SUMMARY AND RESPONSE TO PUBLIC COMMENTS

Permit No: Aquifer Protection Permit (APP) No. 511633, LTF 61397

Facility Name: Gunnison Copper Project

Permit Action: Response to comments received during the public comment period: June 14, 2017 to August 4, 2017

Figure 20: Figure 60 from Appendix I showing the simulated groundwater contours and groundwater velocity vectors for model layer 3, year 21, the end of Stage 3 mining.

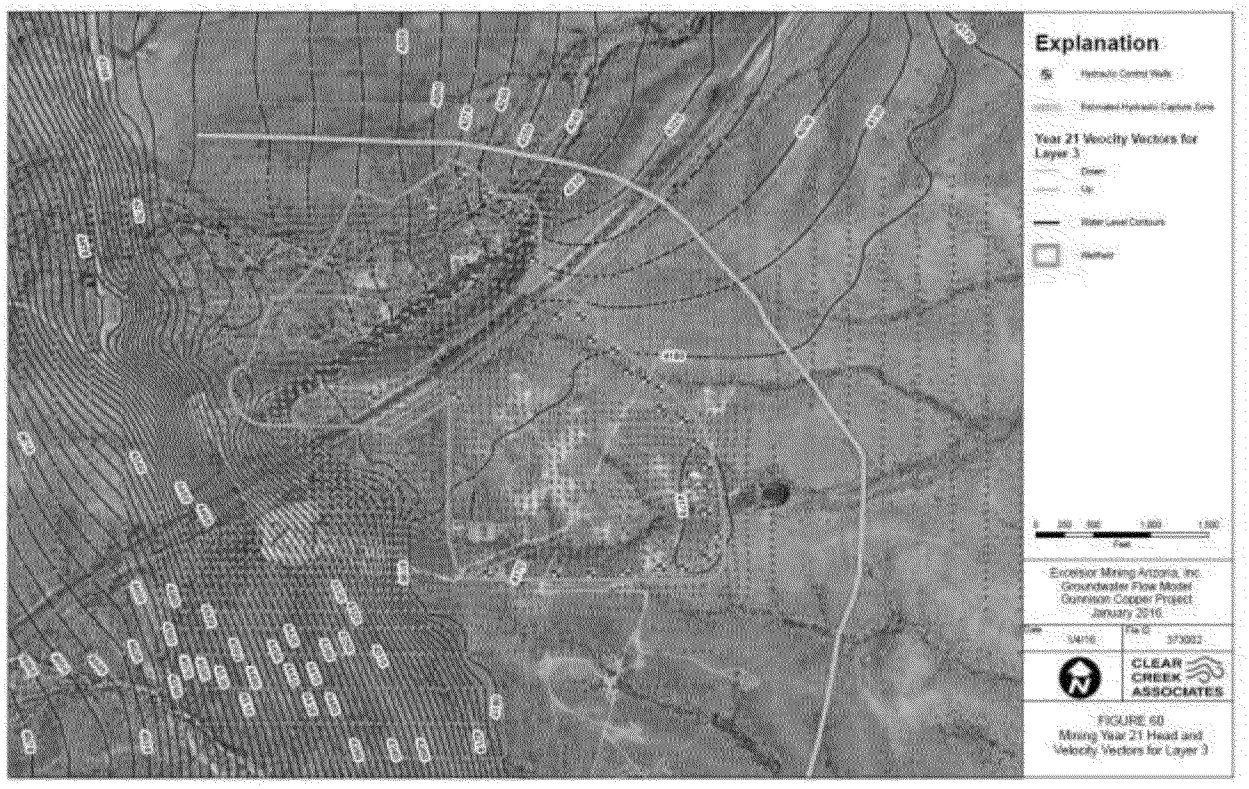
Not all areas within a drawdown cone are areas in which the groundwater flow is toward the middle of the cone. If the baseline groundwater contours dip steeply in one direction, a drawdown may just be a change in slope and the flow may still be away from the cone. Figure 20 shows groundwater velocity vectors (arrows showing direction with the length of the arrow proportional to the speed of groundwater flow) and the groundwater contours (not drawdown) for year 21 (not accounting for injection/collection wells). On the north, west, and south, the groundwater contours naturally slope steeply toward the well field, but in the east and southeast the contours define a relatively flat surface. The surface is so flat that small changes would could cause directional changes in the velocity vectors. The contours in Figure 20 are based on the average head for a specific cell. There is a 4170 contour around the southeast corner of the wellfield delineates a trough in the contours, meaning that simulated flow isto

the center of the trough. Based on the estimated capture zone line, the yellow line on Figure 20 which shows the position of the groundwater divide, the water level is relatively flat throughout the southeast quarter of the wellfield. The mound in the water table represented by the capture zone line is only a few feet higher than the water table in the southeast corner of the project. The pressure at different levels in the groundwater, from the water table surface to a point below the well field, could easily vary from that estimated by consideration only of the water table due to different transmissivity flow paths. Contaminants could escape from the hydraulic control through preferential flow paths through the mapped divide because the average heads in the model cells may not represent actual heads in the fracture zones.

Clear Creek should provide figures similar to Figure 20 for other time periods and for other model layers. Simply maintaining a drawdown is insufficient; it is necessary to maintain a hydraulic low point wherein no flow from the well field can escape into the regional flow field.

ADEQ response to Comment #6.33
ADEQ does not agree. Excelsior evaluated how particles would behave when released at the beginning and end of mining certain mining periods. Excelsior in April 2017 Response to ADEQ comments provided additional evaluataion of how particles would move if there was an excursion. The following figures shows how far an excursion would go under certain conditions and whether the excusion would be recovered. The figures are as follows: Figure 8-2 "Closure Strategy Particles and Well Rates Mining Year 1", Figure 8-3 "Closure Strategy Containment after Shutdown Mining Year 1", Figure 8-4 "Closure Strategy Pumping Rates for Wells Mining Year 5 Closure", Figure 8-5 "Closure Strategy Drawdown after Year 8 Mining Year 5 Closure", and Figure 8-6 "Closure Strategy Particles Traces Mining Year 5 Closure" (Please see the attached figures below in ADEQ Response Figures). In addition, the purpose of the IMWs is to evaluate groundwater flow model predictions and evaluate potential fluid channels during operations to prevent large excursions from reaching the POC wells.
